Objection submission COM/2019/81 - Flyrock safety Concerns

Further to my objection dated 17th September 2020: 'Flyrock safety precautions'. Please accept this objection as the contents of my original objection are somewhat outdated by the applicants changes submitted in February 2021. This objection highlights the rules and guidelines and safety concerns surrounding flyrock at existing quarries that appear to have been ignored in the Development Application for the Nucrush Quarry.

Attachment H2 - Plan C1495:00:13B (Showing close-up of Rural 'B' area)

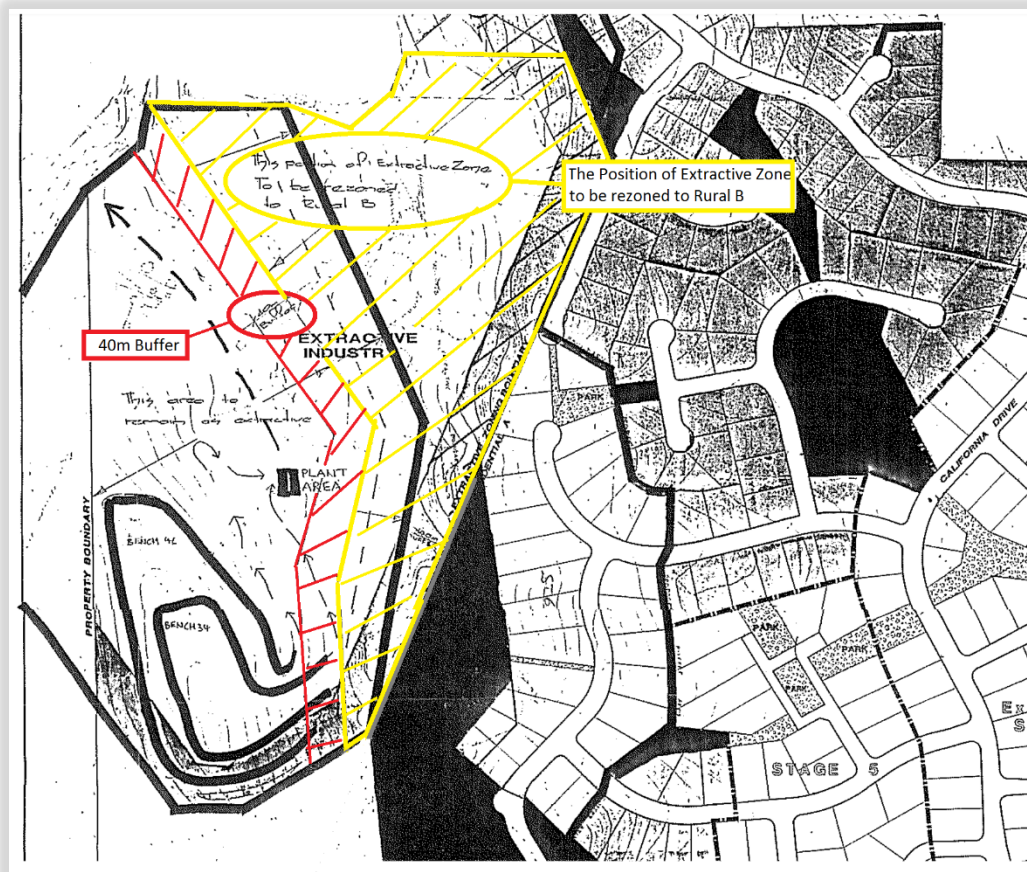
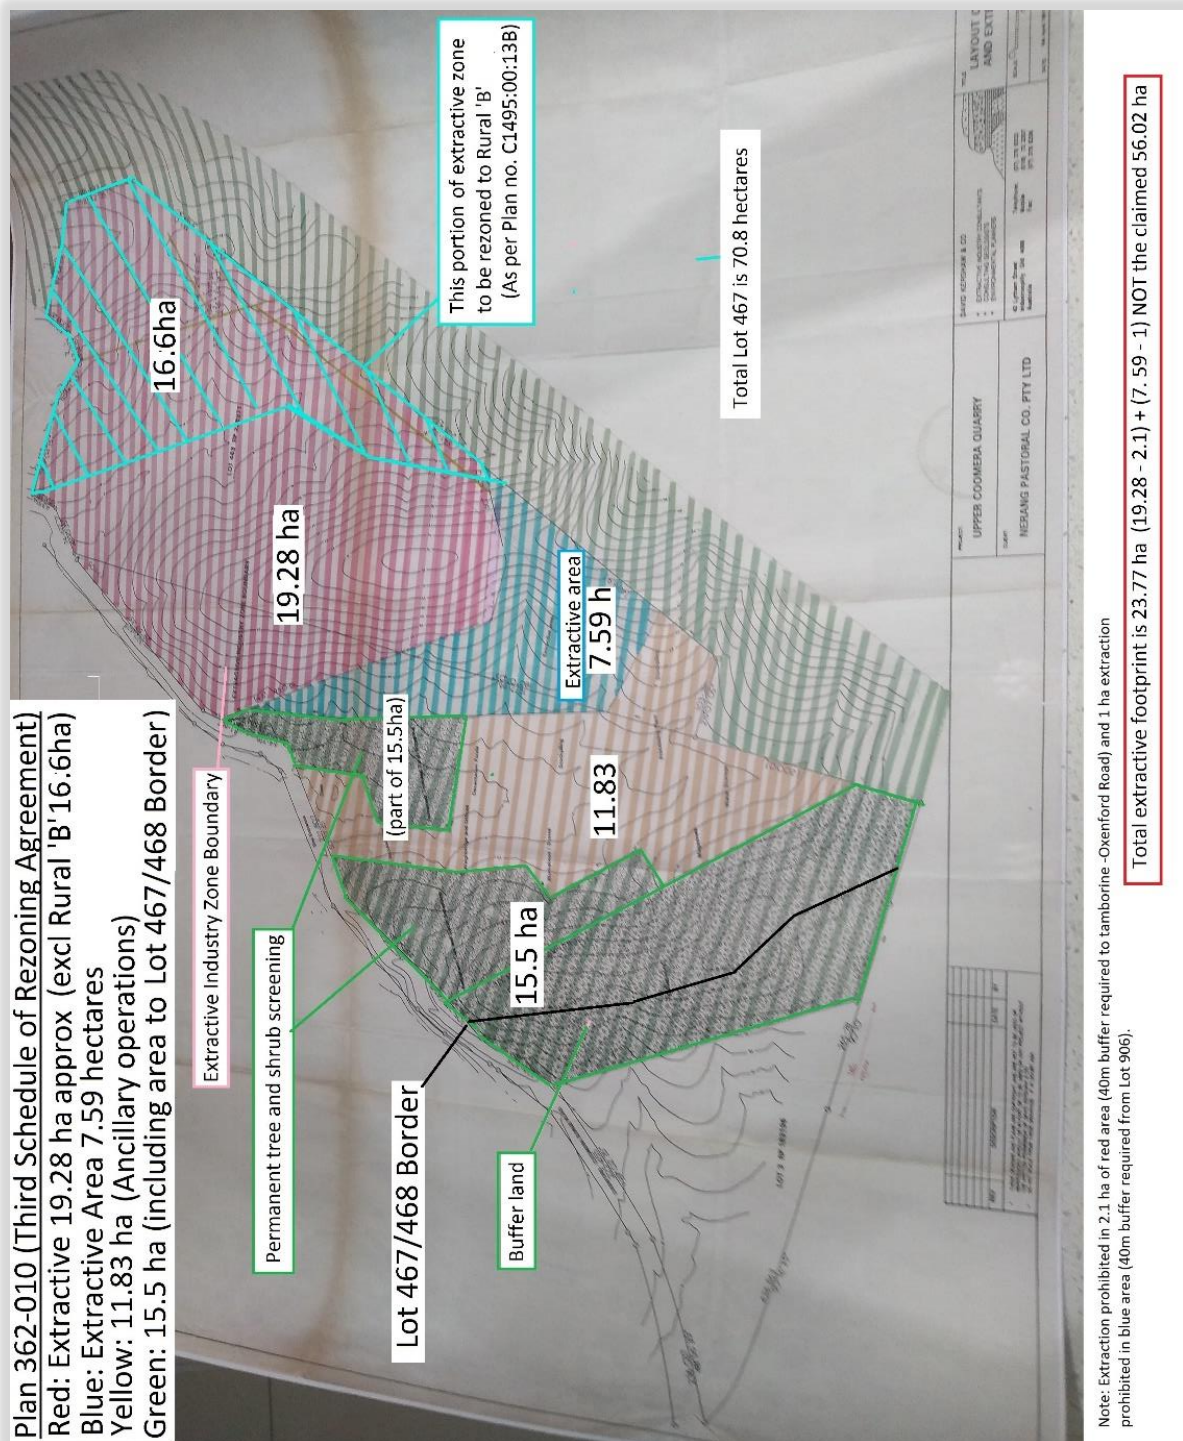
** Similarly, please note plan 'C1495:00:13B', reproduced in Attachment H1,, revealing detailed information concerning the prohibited development area known as "Rural 'B' ", appears to have been culpably omitted from the development application. This too was only discovered in the subsequent 'Right To Information' (RTI) enquiry to the Gold Coast City Council.*

Attachment H3 - Plan C1495:00:13B (Showing annotated close-up of Rural 'B' area)

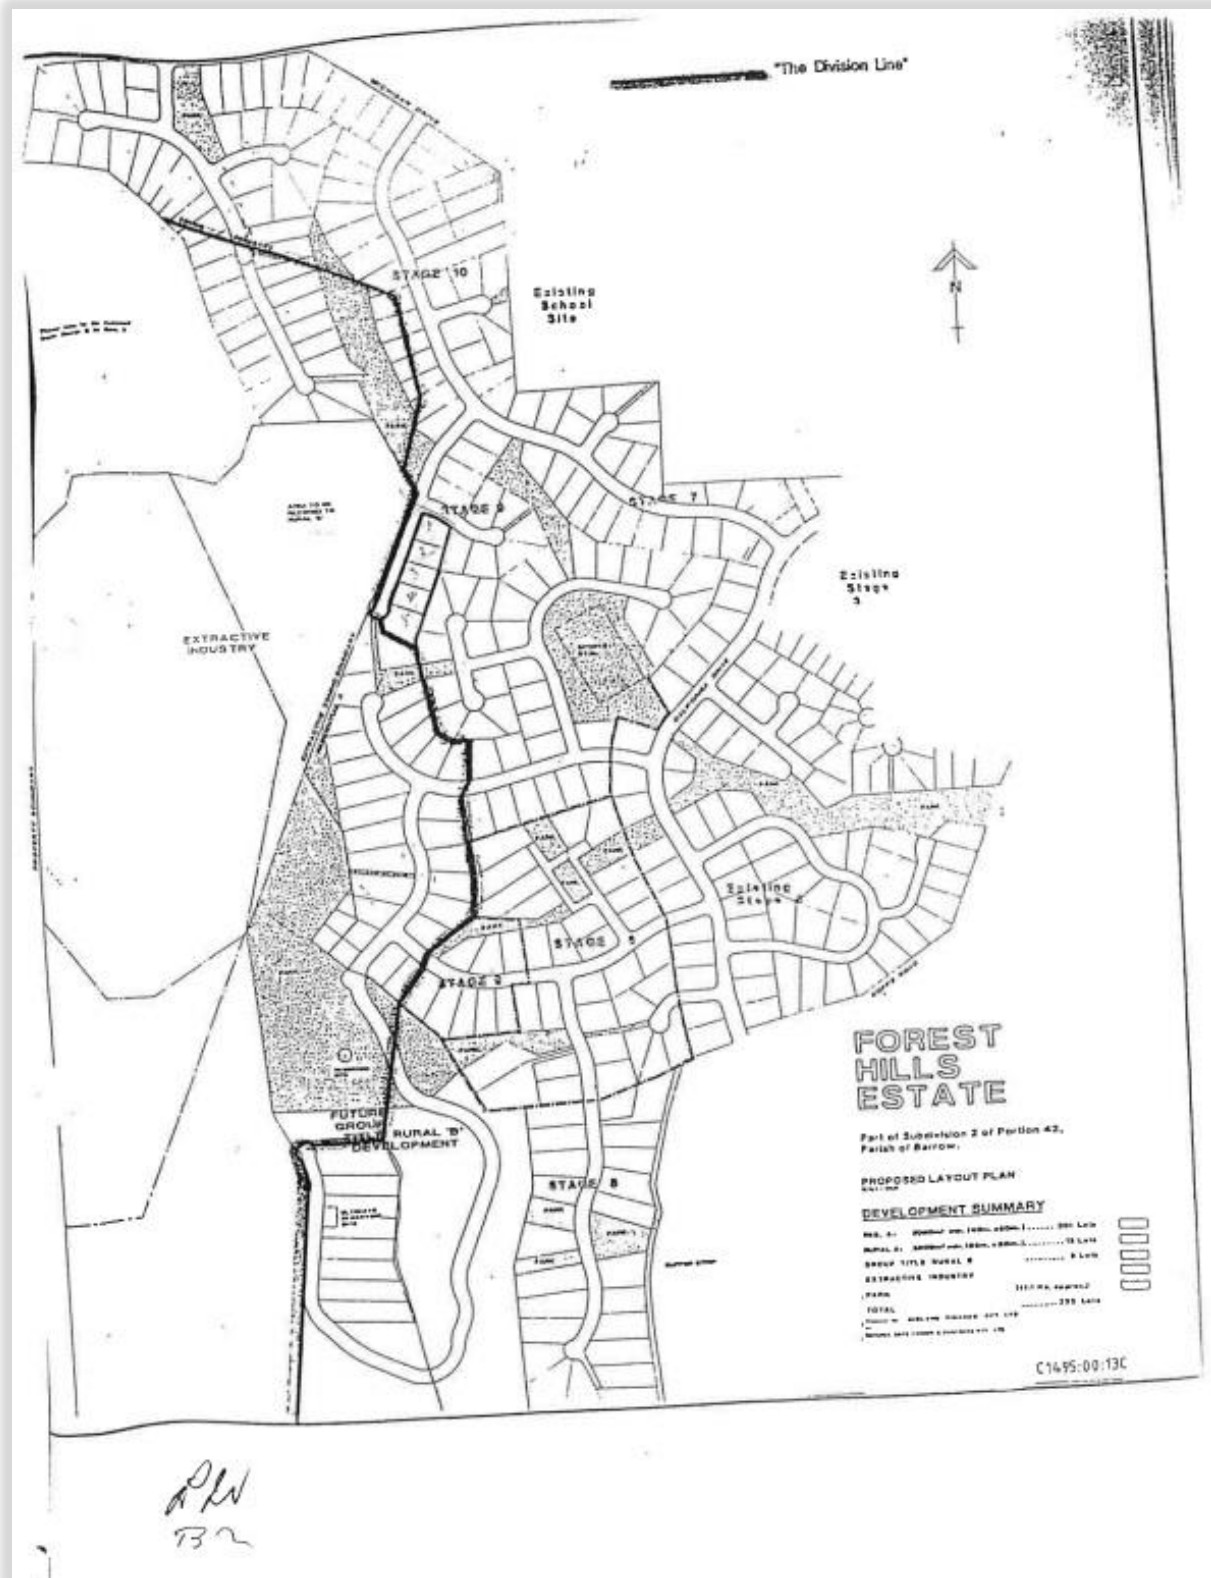
Note title "FOURTH SCHEDULE" has seemingly been removed and signature changed. Original shown in Attachment H6 below.
